# ENCORE APARTMENTS

DPD # 3020094  
2ND DESIGN RECOMMENDATION  
20 DECEMBER 2016

**PROJECT ADDRESS:**  
3010 1st Ave.

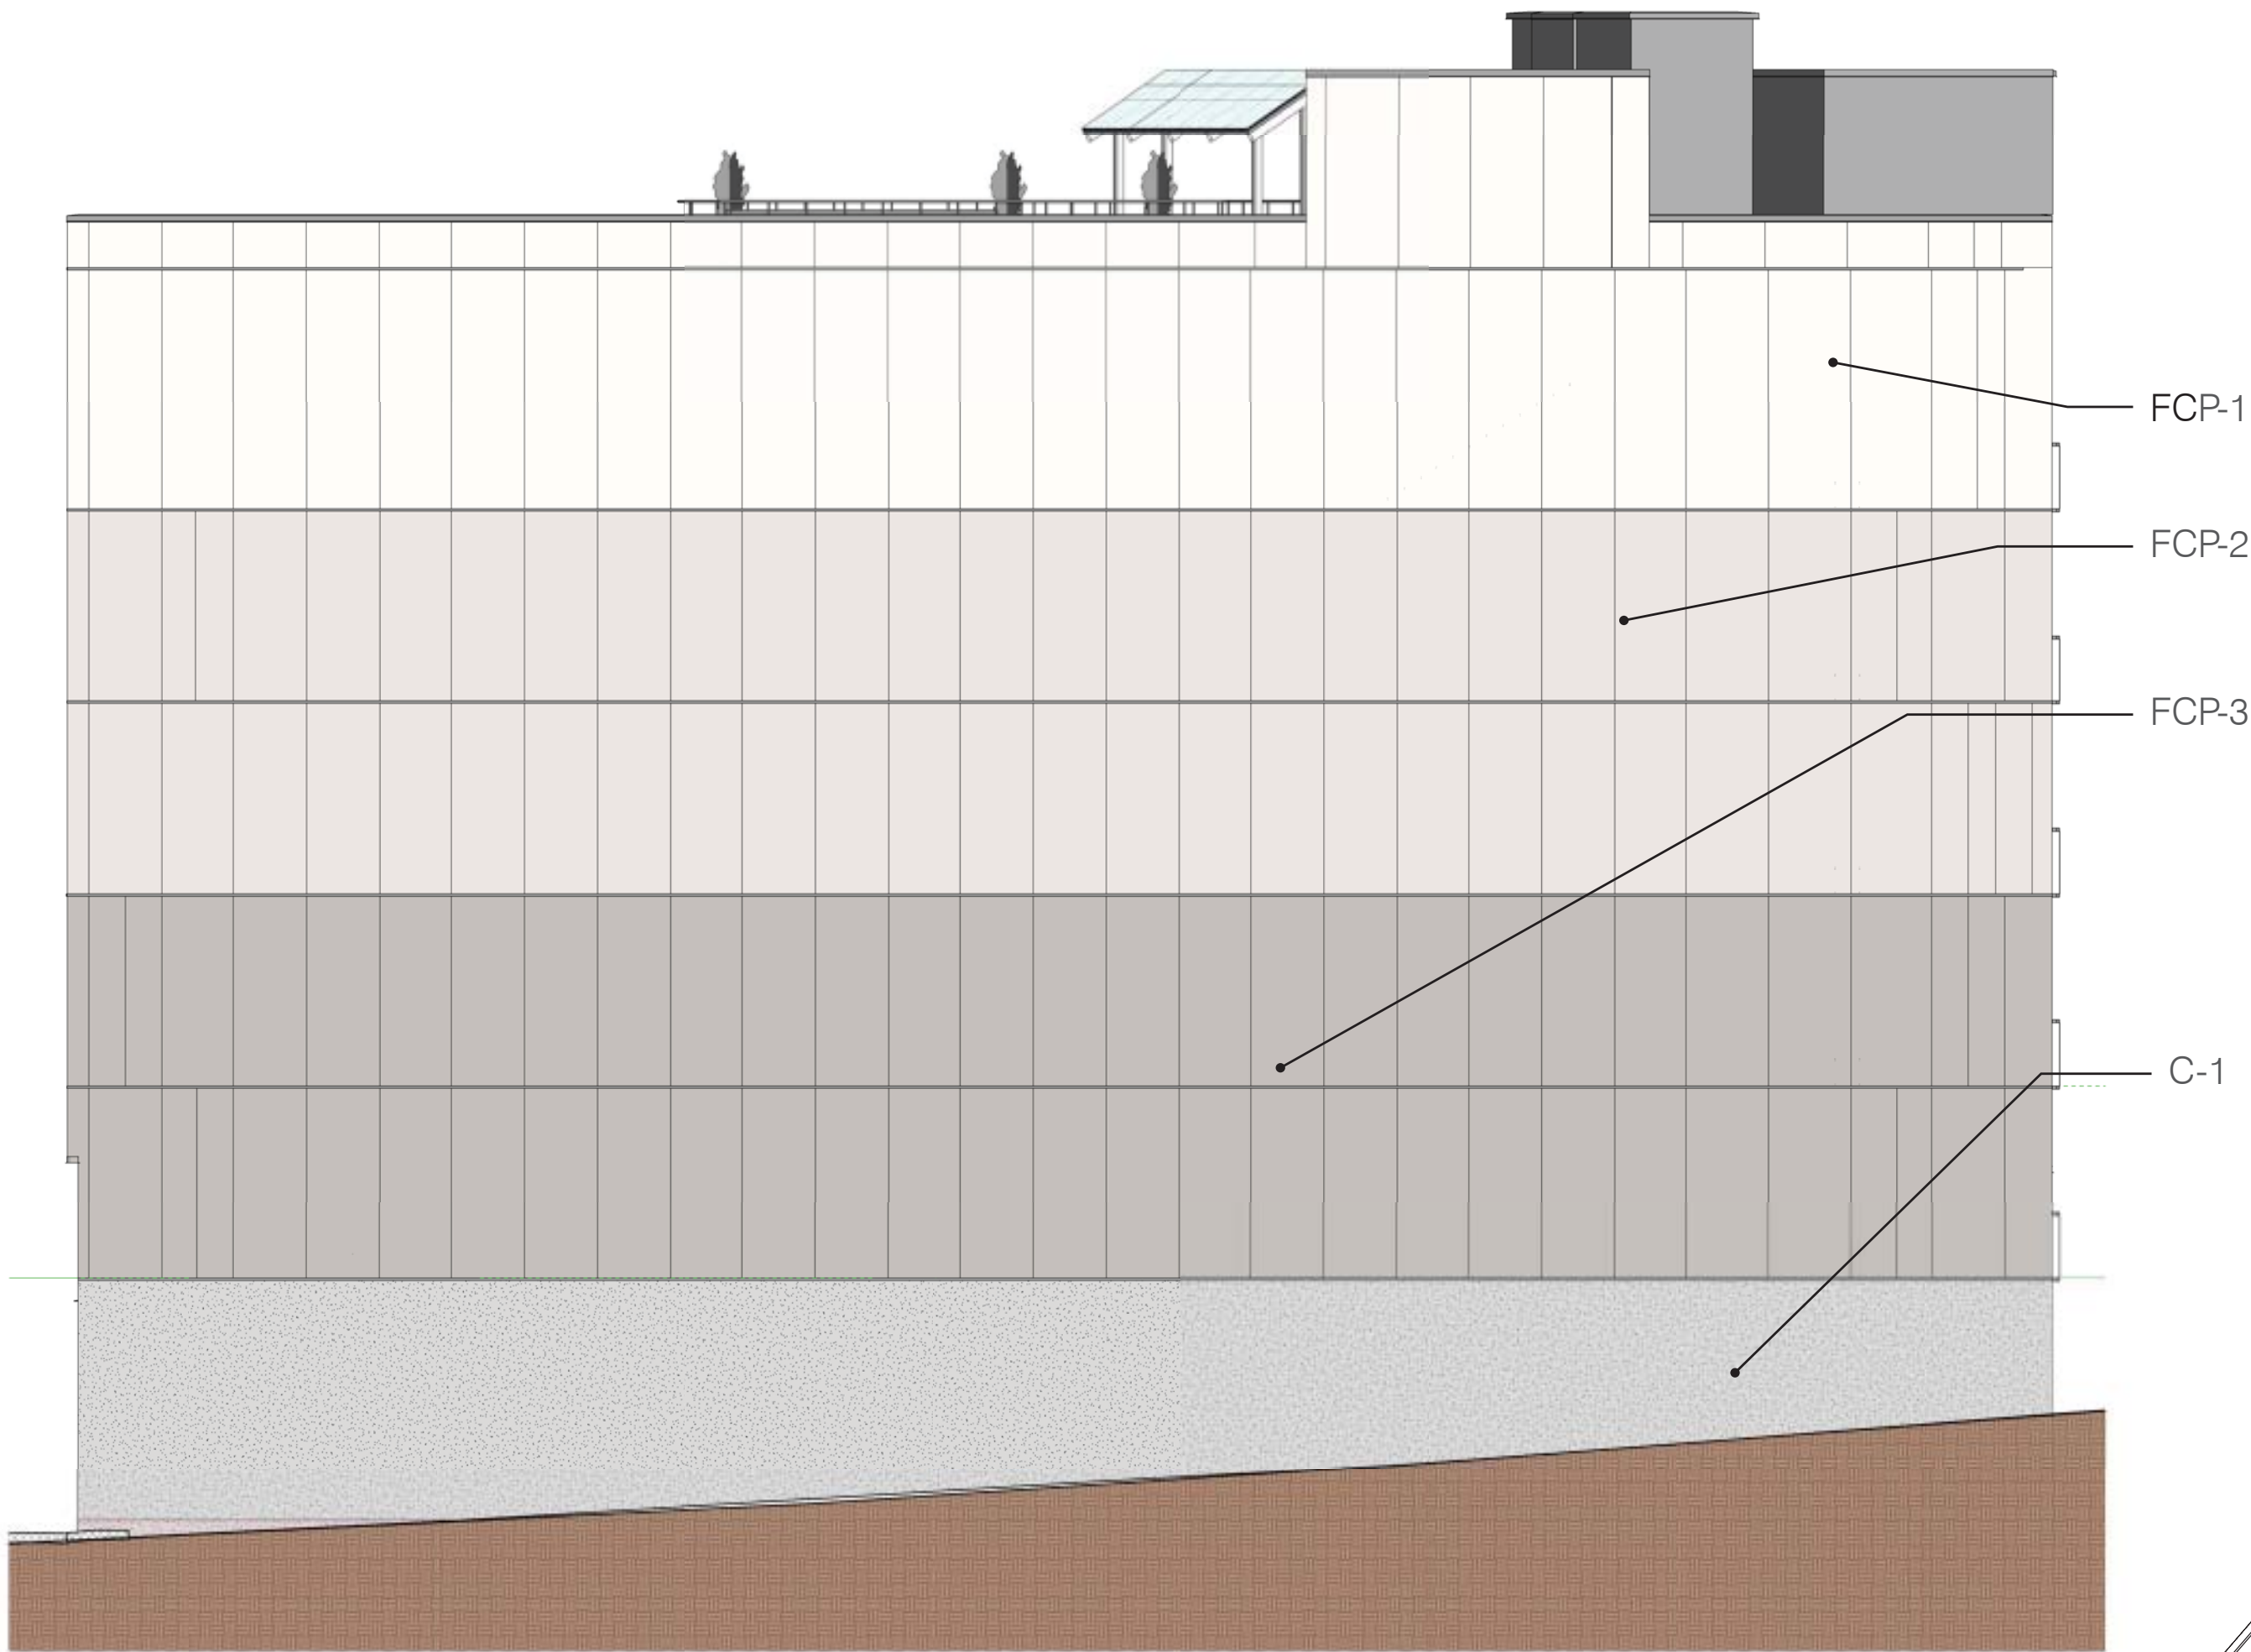
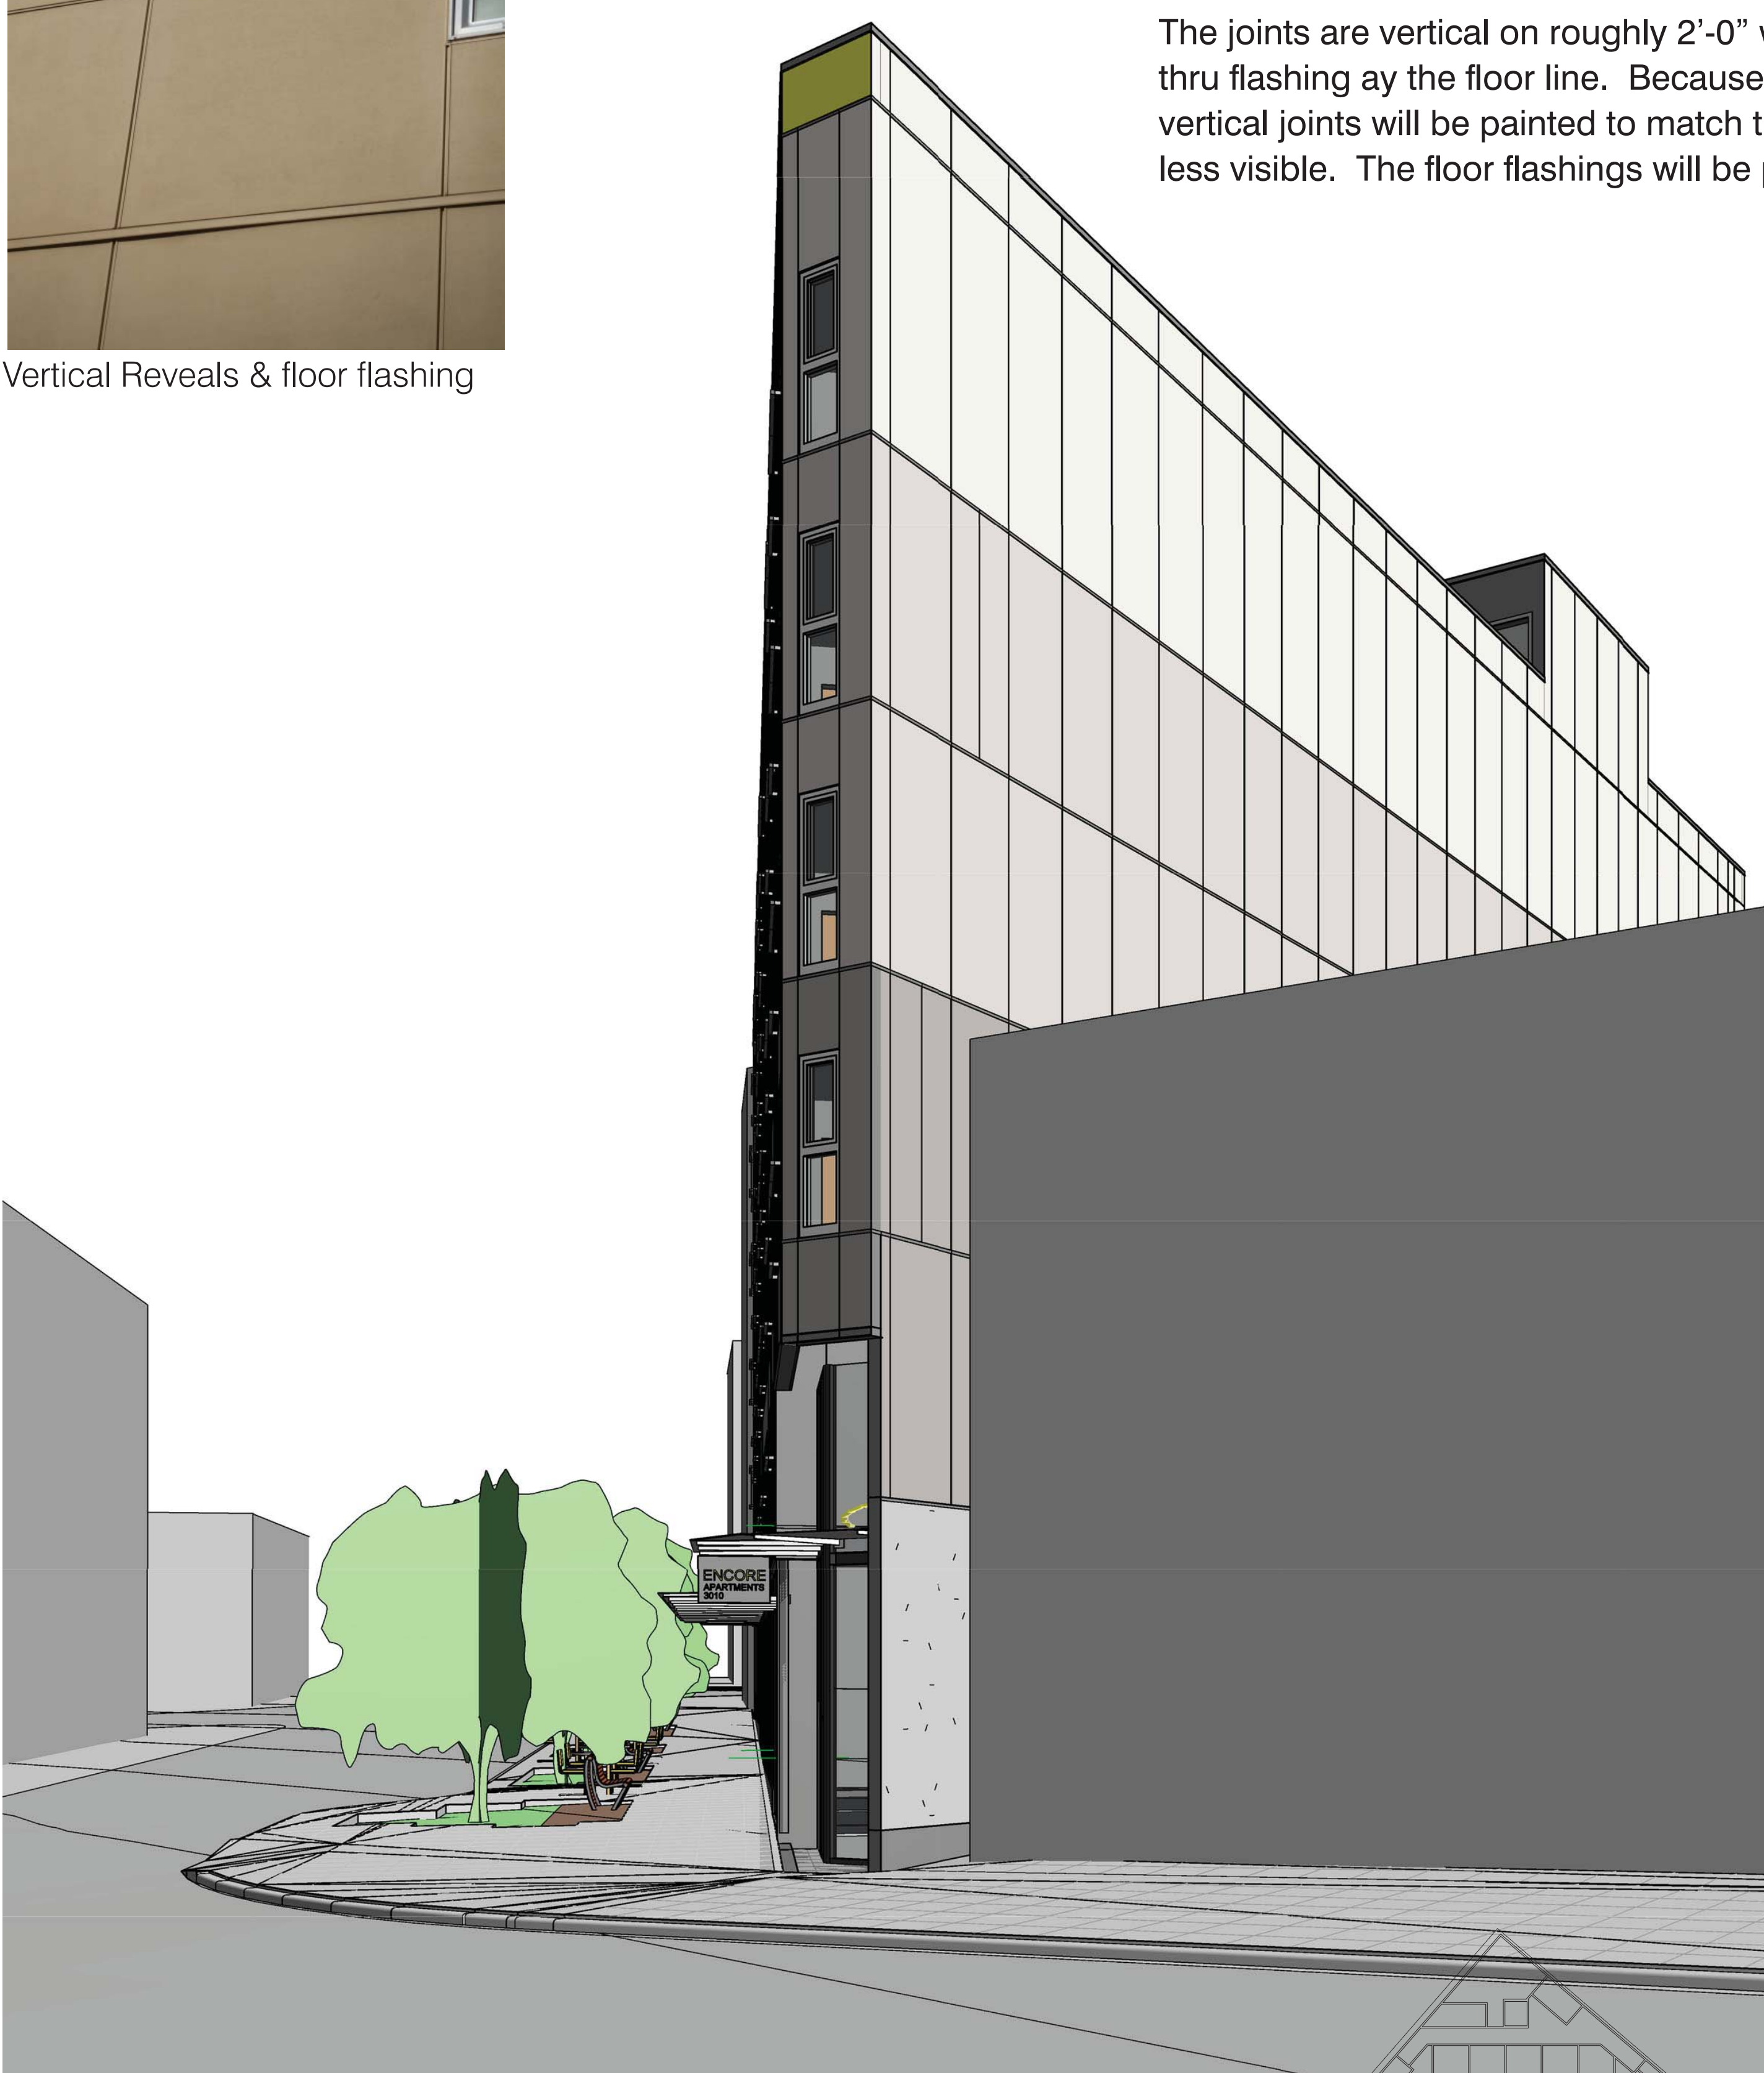
“...The Board agreed that the banding of color appears to take away from the wholeness of taut skin expression. The board recognized that the unique shape of the site warrants a quirky response... (B4.2, B4.3)”

This is a variation of the color/material scheme presented in the 1st DRB Recommendation Mtg: the gray colors were changed; the color of the vinyl windows and storefront were made black. The subtle shifting of grays in the field from bottom to top “lightens” the perceived building mass without creating an overly busy facade. The variation in stacked windows creates a secondary facade element of complexity. The yellow colored decks provide a third facade element of complexity. The intent is to perceive layers in the facade. This scheme is a bit “quirky”, but not obnoxiously so. It’s appropriate for a moderately quiet building on a side street.
